Item ID: D209-669-043 Accept ***N900040100*** Setup Start ***NS1***
 Revision ID: Stop ***NS2***
 Item Name: AH-1F/P/S Replacement Skidtube with Standard Wearplates, Fits LH or RH
 Start Date: 2/8/2016 Start Qty: 1.00 ***1*** Cust Item ID:
 Required Date: 3/11/2016 Req'd Qty: 1.00 ***1*** Customer:
 Reference:

DRAWING NO. D2906	TITLE AH-1 (209) SKIDTUBE ASSEMBLY	REV. B	DART AEROSPACE LTD ENGINEERING ORDER		D.E.O. NO. D2906-B-1	SHEET NO. SHEET 1 OF 1	SCALE NTS
DRAWN A.P.	CHECKED <i>[Signature]</i>	MFG. APPR. <i>[Signature]</i>	APPROVED <i>[Signature]</i>		DE APPR. <i>[Signature]</i>		
DATE 12.05.28	DATE 12.05.28	DATE 12.05.31	DATE 12.05.31		DATE 12.05.31

CHANGE ALL C'BORED WELDED CROSSBOLT SPACERS TO SWAGED SPACERS

SECTION C-C A2-2
NOT TO SCALE A2-3

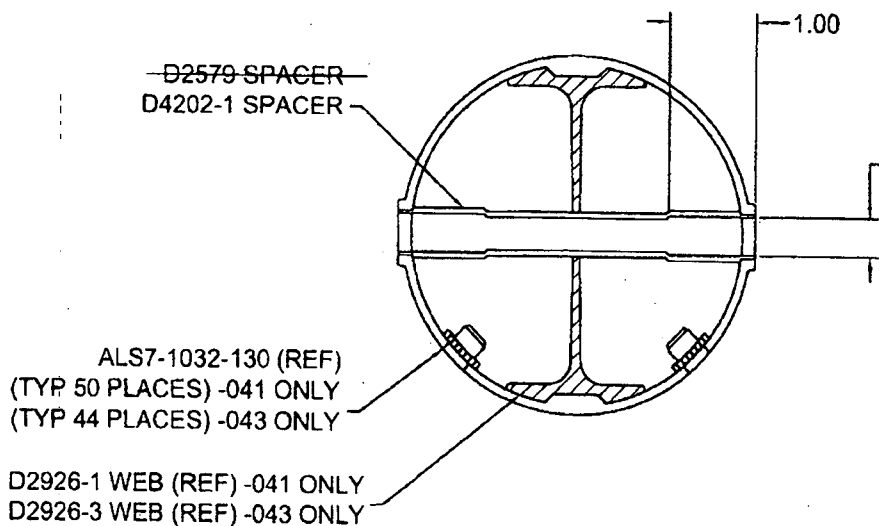
SECTION C-C ON SHEETS 2 & 3 ARE AMENDED AS FOLLOWS FOR ALL HOLES THAT WERE ORIGINALLY C'BORED:

AFTER DRILLING AND BENDING ASSEMBLY
PERFORM THE FOLLOWING FOR Ø0.508 HOLES ONLY:

1. CHAMFER HOLE 0.050 X 45°
2. INSERT D2579 SPACER (20 PLACES)
3. WELD INTO PLACE AND GRIND FLUSH
4. C'BORE D2579 SPACER TO Ø0.437 X 1.00 DEEP

1. INSERT D4202-1 SPACER, 22 PL (-041) OR 19 PL (-043)
2. SWAGE TO Ø0.437 X 1.00 DEEP PER QSI 002
3. TRIM / GRIND FLUSH PER QSI 002
